ARCHITECTURAL REVIEW FINDINGS AND DECISION

**** APPROVAL WITH CONDITIONS ****

Case #:	AR-16-0007
Project:	Sagert Farm Subdivision - Fencing
Location:	20130 SW 65 th Avenue (Tax Lot 21E30B 00300 and 00600)
Applicant:	Lennar Northwest; Darrel Smith, 11807 NE 99 th Street, Suite 1170, Vancouver, WA 98682
Project Contact:	3J Consulting; Andrew Tull, andrew.tull@3j-consulting.com; 5075 SW Griffith Drive, Suite 150, Beaverton, OR 97005 (503) 545-1907

SW 65TH AVE (CMU WALL) - PROFILE VIEW
STA: 1+00.0 - 2+50.0
SCALE: 1" = 5'

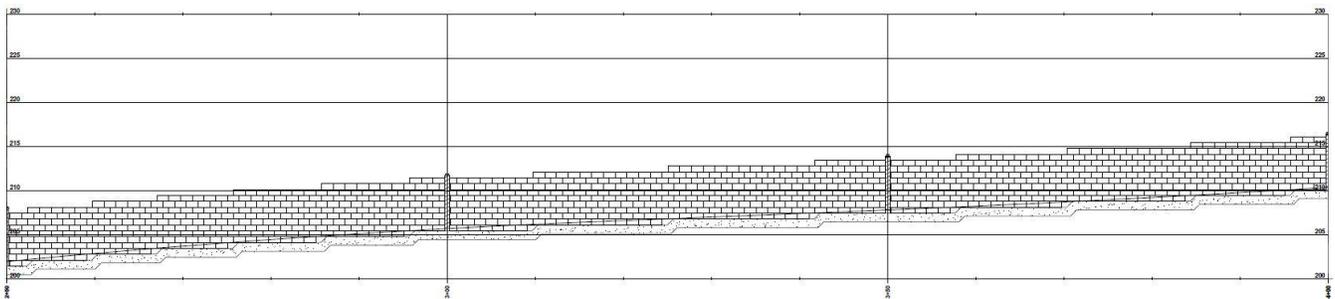
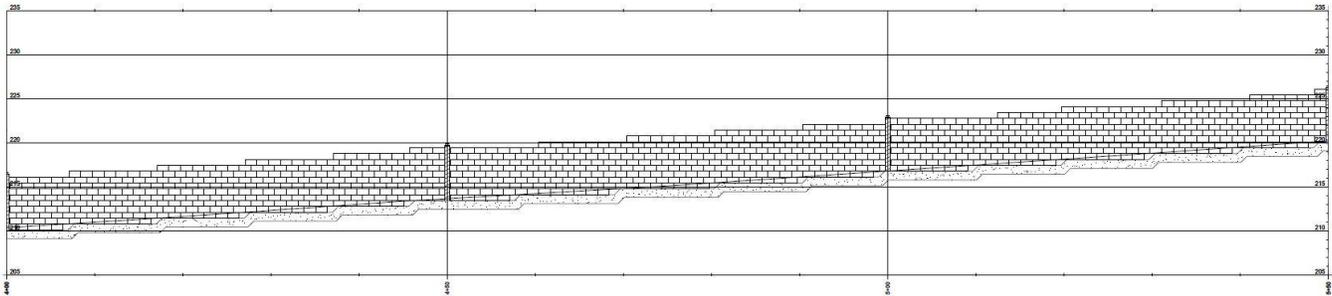
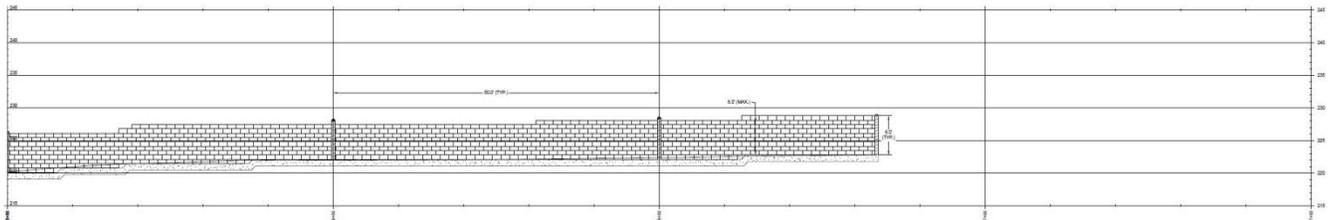
In an email dated July 25, 2016, the Applicant further maintains “The fence along 65th Avenue is constrained by the excessive slope of the roadway causing a situation where the 20-ft column spacing and the amount of steps required in the wall itself would become busy, choppy, and be somewhat confusing to the eye. Section 34.340(1)(c) Slopes is the one design standard set forth that this development is unable to meet given the purpose of implementing the community design objectives of TDC 10.020. In short the excessive slope is creating an unattractive fence design and the applicant wishes to extend the columns from 20-ft to 50-ft.”

Staff finds the Applicant’s proposal does not provide adequate evidence that the fencing is unable to meet the standard per TDC 34.340(2)(a), in order to grant a variance. The fence as proposed isn’t incorporating the wall stepping intervals in an orderly manner; therefore pilaster spacing does not seem to be dictated by wall stepping intervals. The Applicant also hasn’t provided linear foot dimension of frontage along access restricted roads to further support their findings for regularly spaced intervals outside of the required standard. The standard is in place to provide a visual break in the fence paneling and to encourage a structurally sound fence design. Staff recommends iteration of this standard as a condition of approval.

Condition of Approval: The Applicant shall submit revised site plans that uniformly demonstrate pilasters or architectural feature will be set at approximately regular intervals and spaced no more than twenty feet apart of center. Pilasters shall be installed according to revised plans and shall be installed perpendicular to a zero-slope plane.

3 TYPICAL REINF. AT STEPPED FOOTING
 SCALE: 1" = 1'-0"

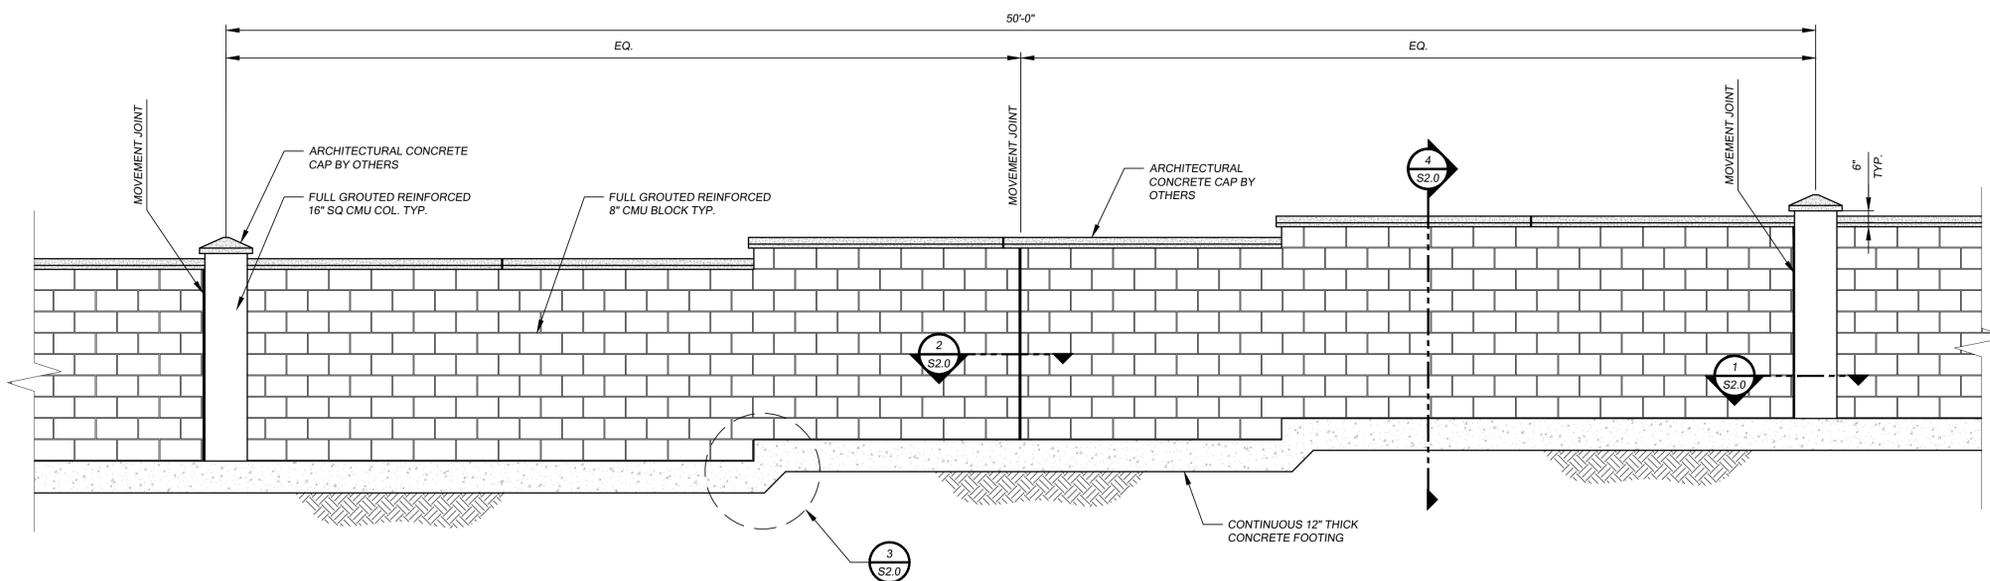
The proposed CMU wall along SW 65th Avenue will be constructed using a stair-step method, as shown on submitted structural plans. The Applicant notes in emails dated July 11 and 25, 2016, that the slope along SW 65th Avenue requires the wall to step at random intervals, especially on the southern end.

Additionally, the Applicant has not provided detailed plans for the proposed cedar and stone fence along SW Borland Road and SW Sagert Street. Staff recommends iteration of this requirement to satisfy the criterion.

Condition of Approval: The Applicant shall submit detailed drawings that demonstrate proposed fence types will be installed using a stair-step method. Applicant shall install fencing according to these plans.

4 TYPICAL FENCE/ WALL SECTION
 SCALE: 1" = 1'-0"

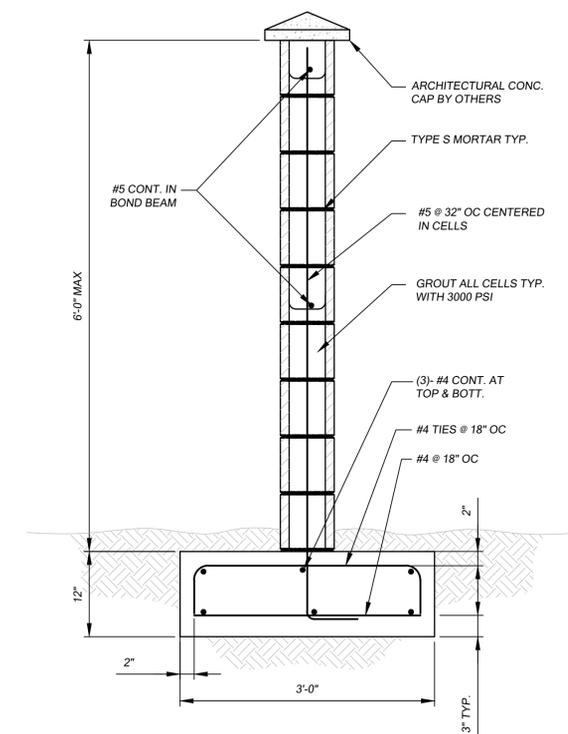
The proposed fence panels along the project's perimeters will be six feet in height for the proposed CMU wall, as shown on C200 and S2.0. Details provided for the cedar fence on sheet C200 are difficult to read. Staff recommends iteration of this requirement to satisfy the criterion.

Condition of Approval: The Applicant shall submit detailed drawings that demonstrate proposed fence types will be six feet in height as measured from the up-slope end of each panel. Applicant shall install fencing according to these plans.
